ST. TAMMANY PARISH

Addendum No.: 1

Bid#: 20-6-2

Project Name: I-10 Service Road Bridge Replacements

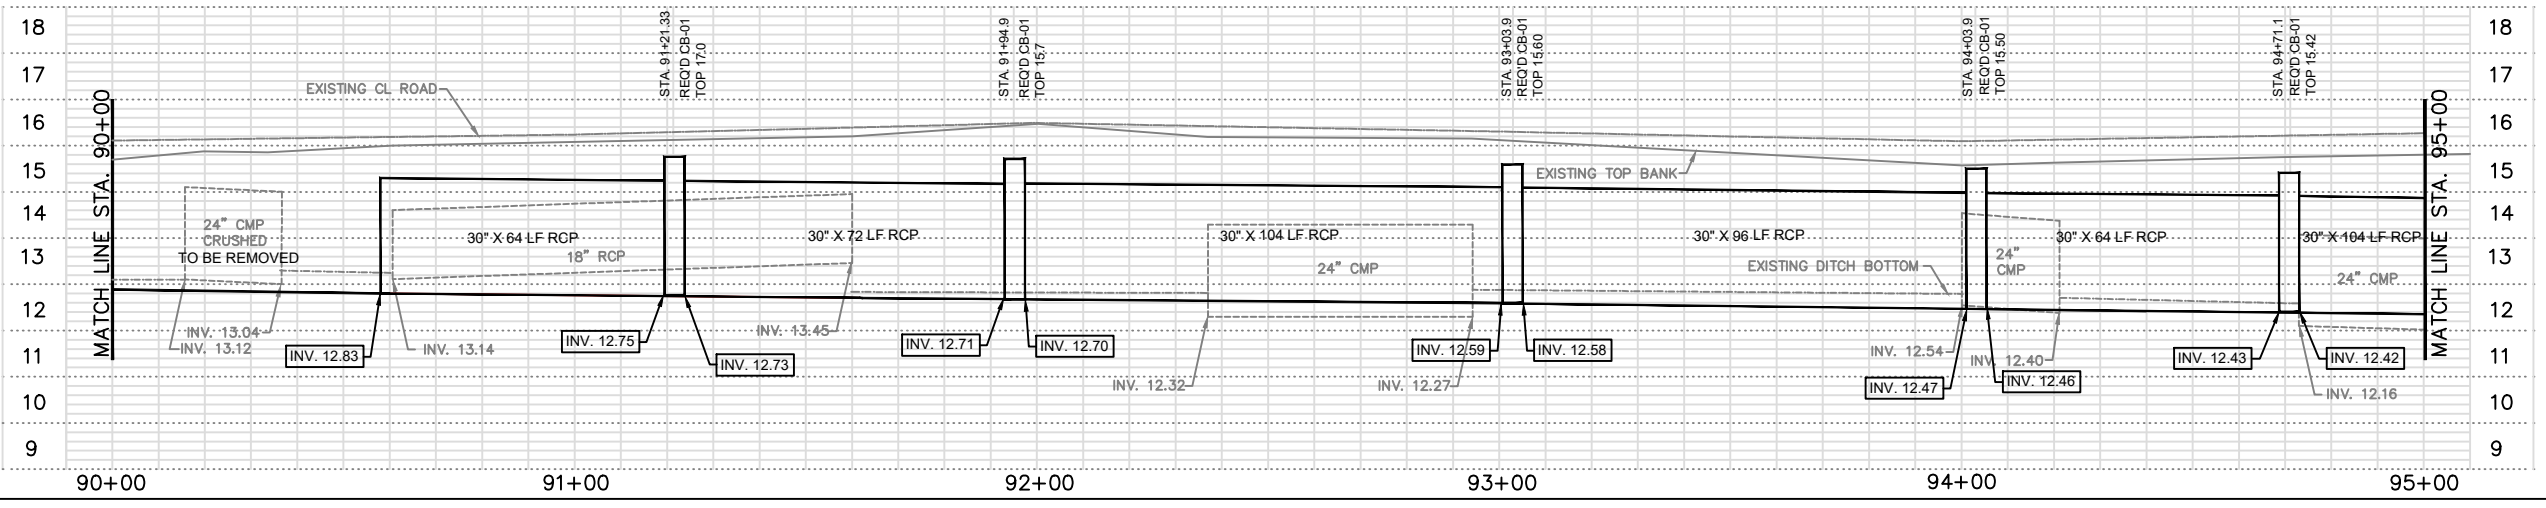
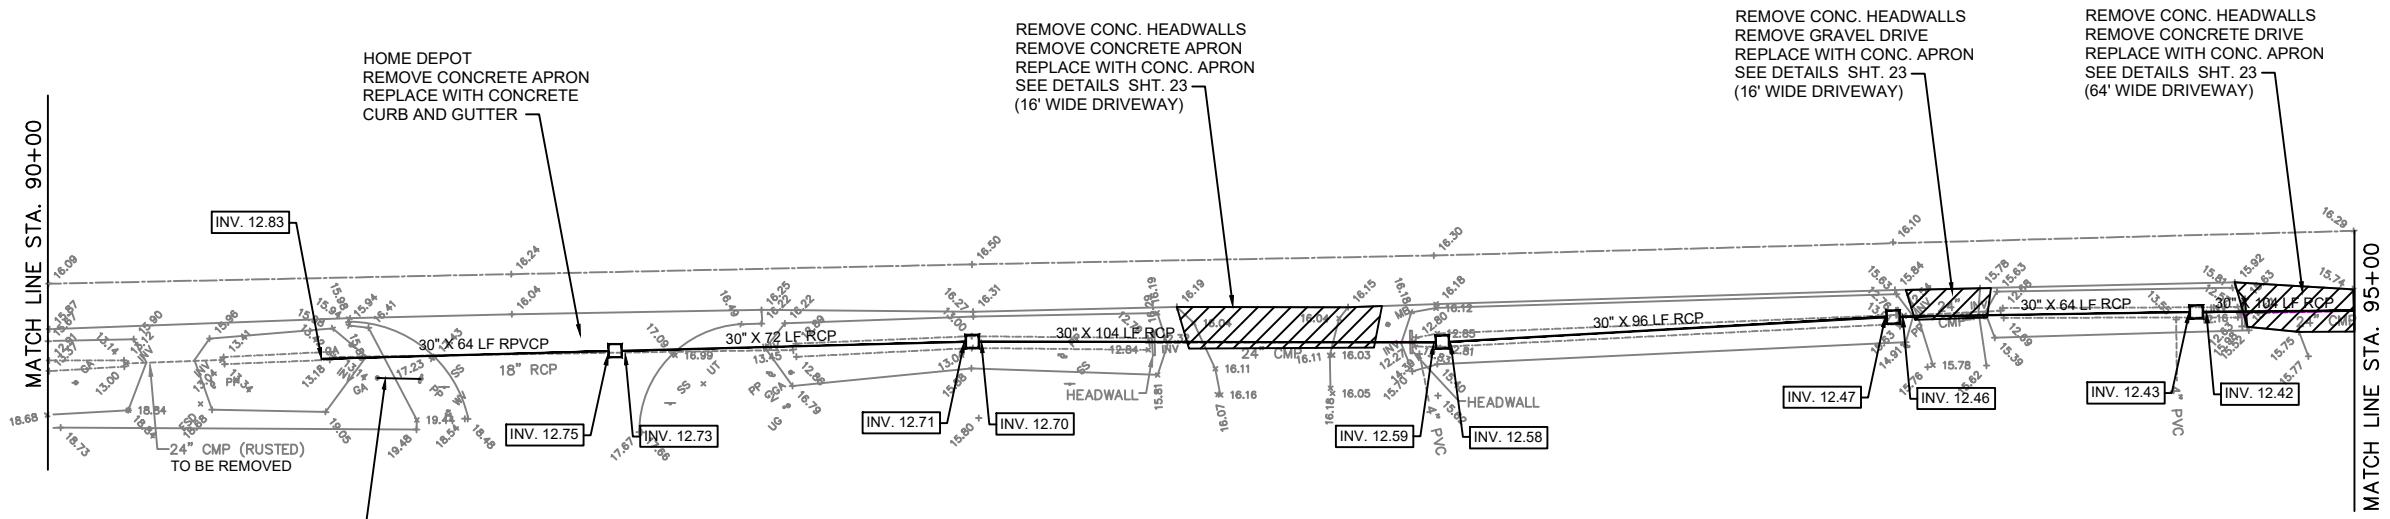
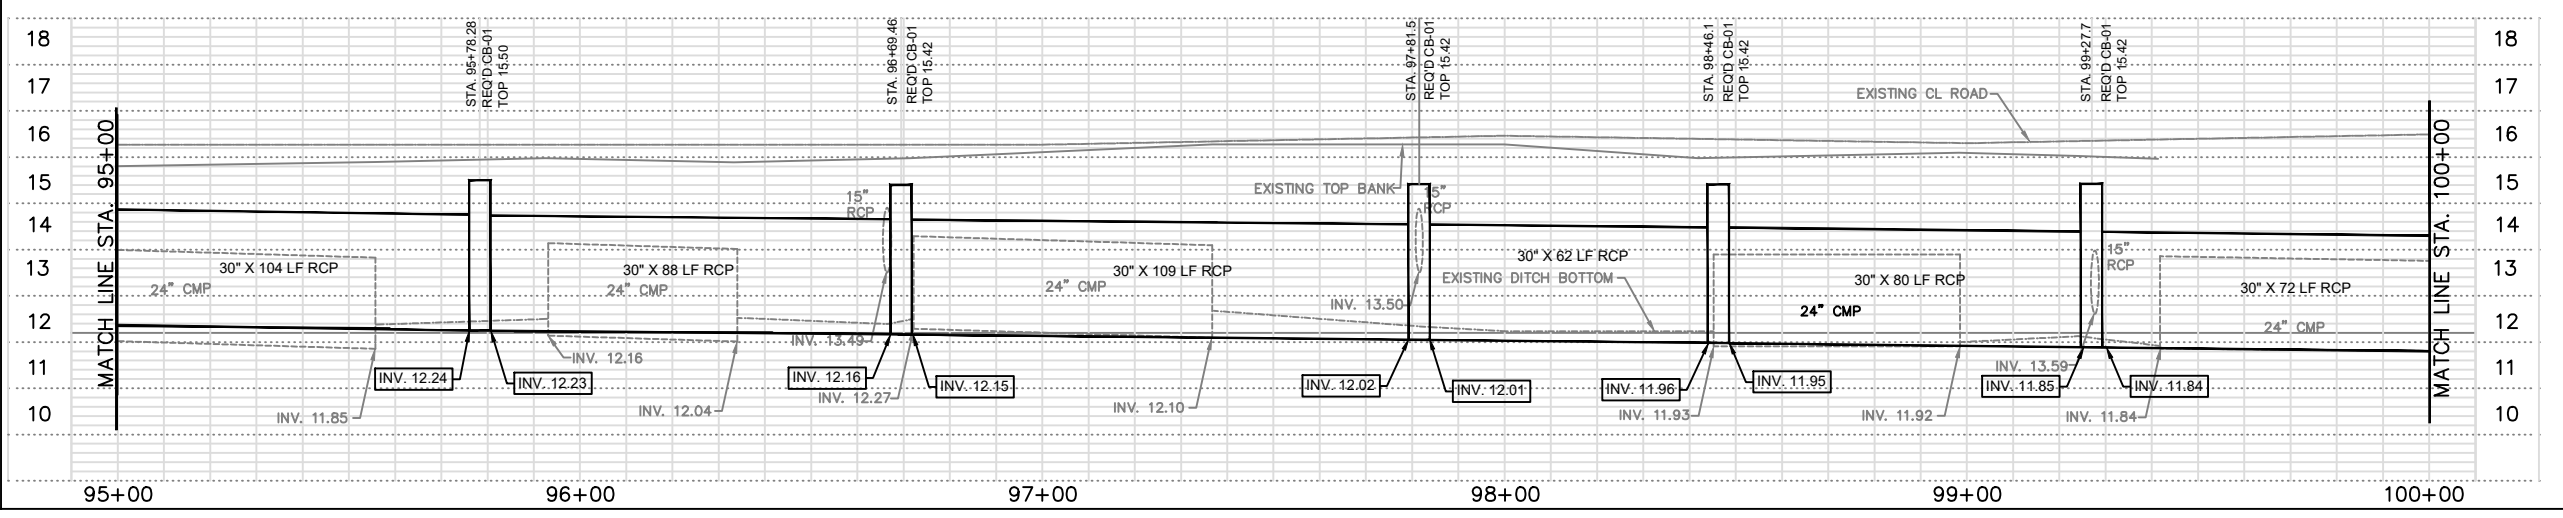
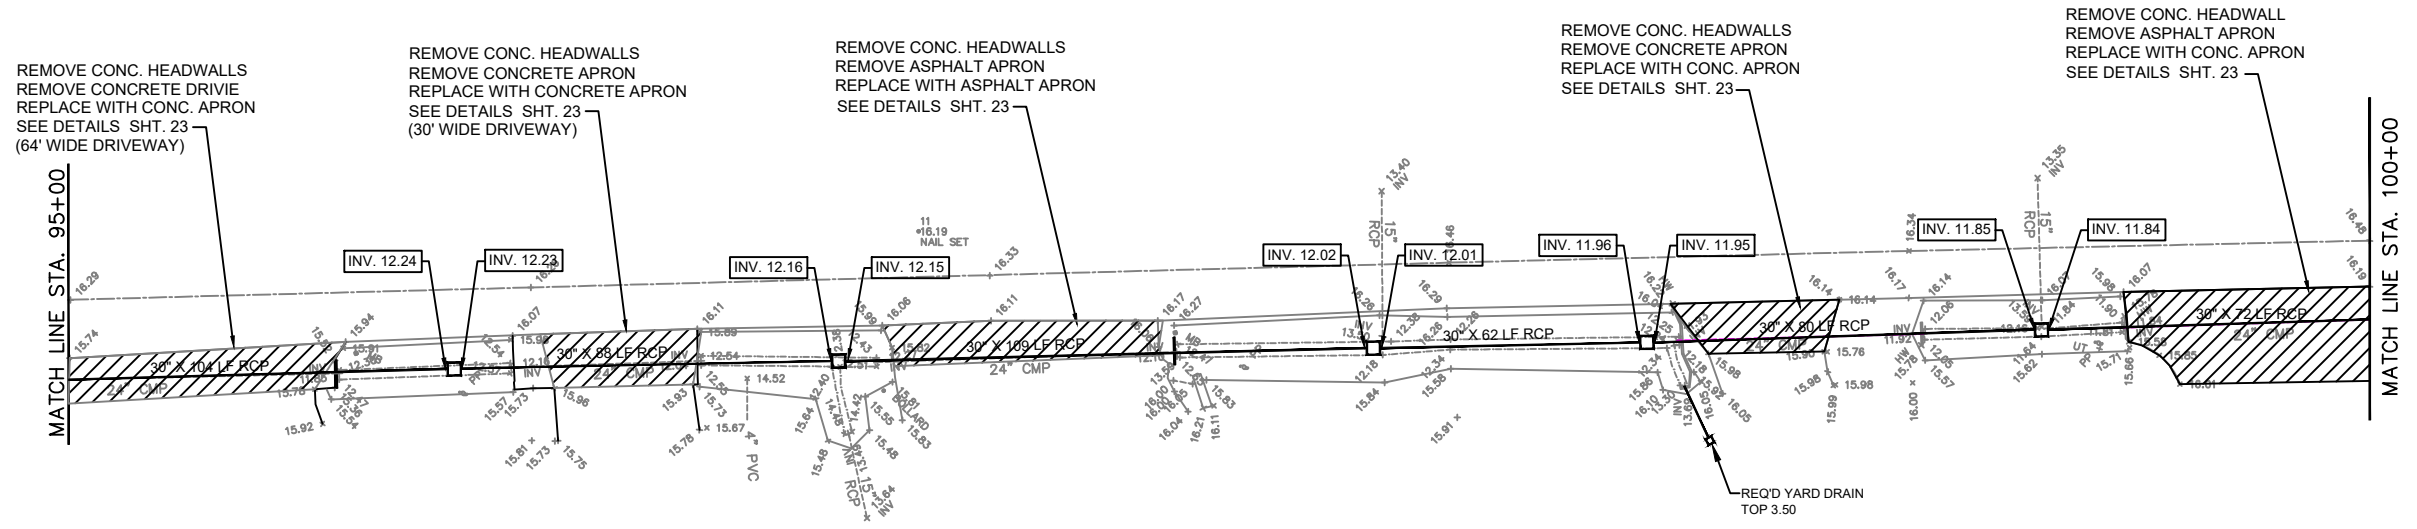
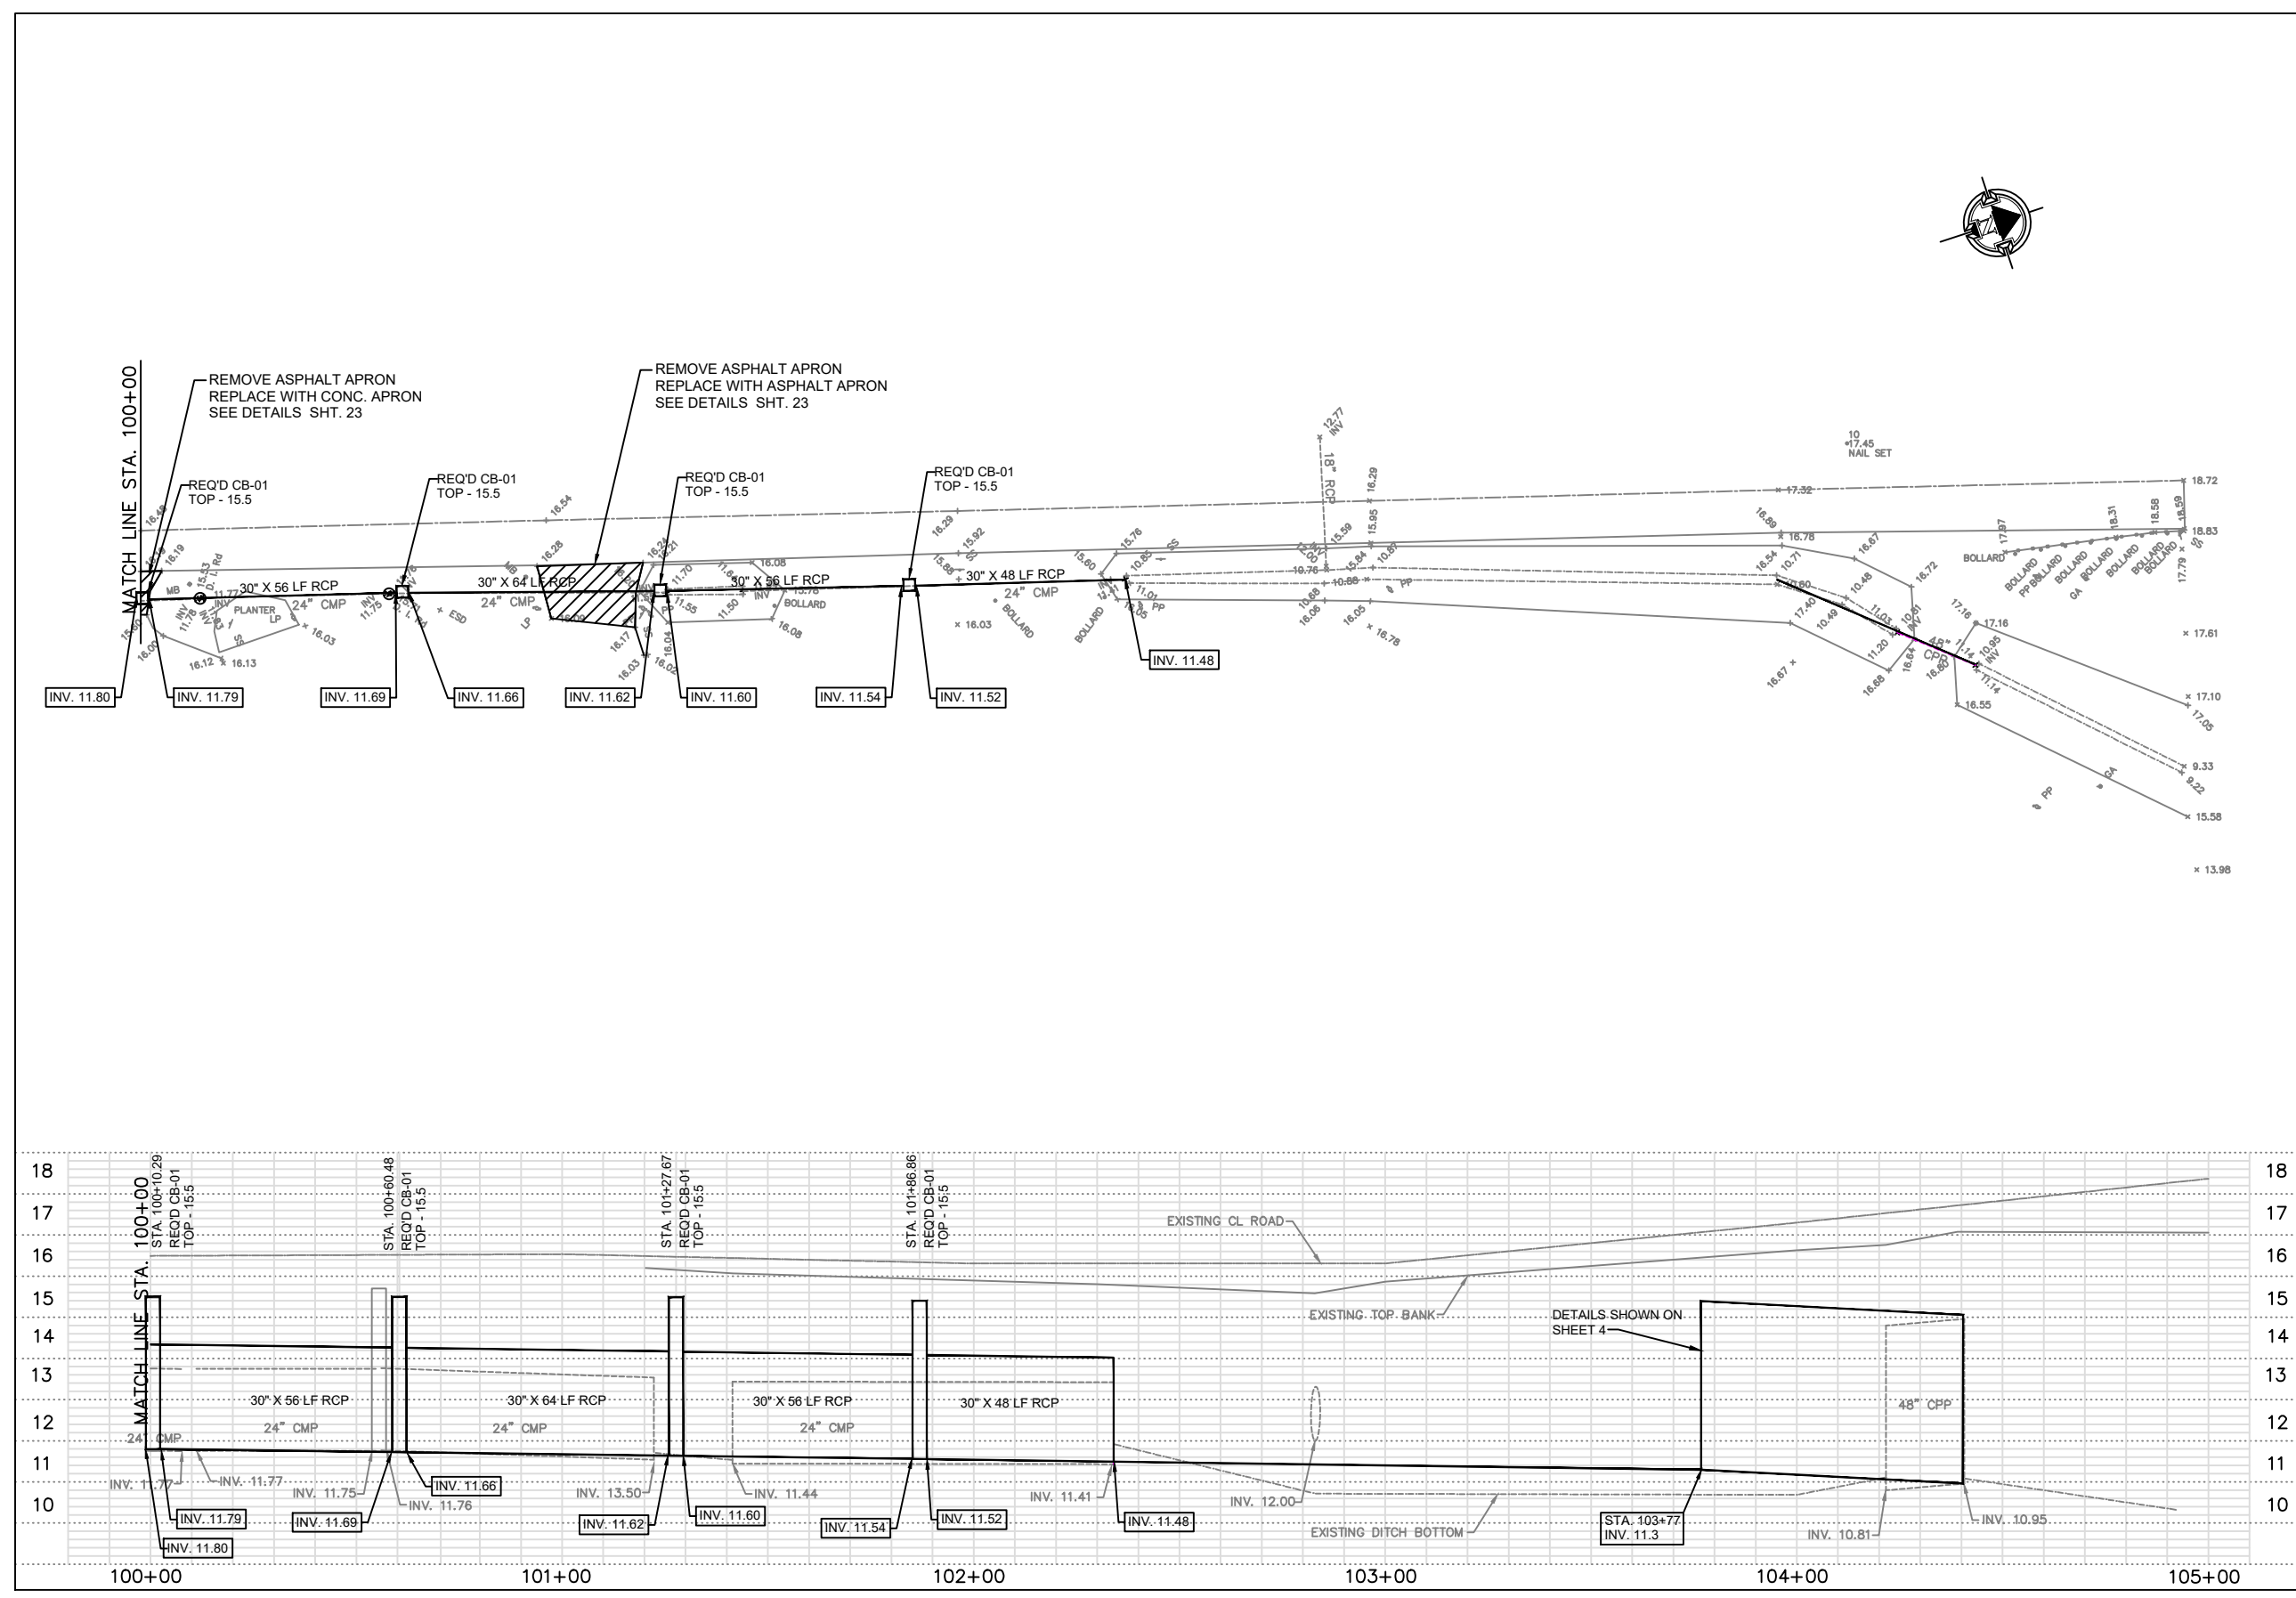
Question 7: The 30" RCPA added to the project in addendum 2 seems to have an incorrect quantity. Adding up the pipe runs on sheets 20-22 comes to a quantity of 1,139 lf. Please advise.

Answer 7: The additional 29 LF of 30" pipe will be used to extend end of the pipe near station 102+50
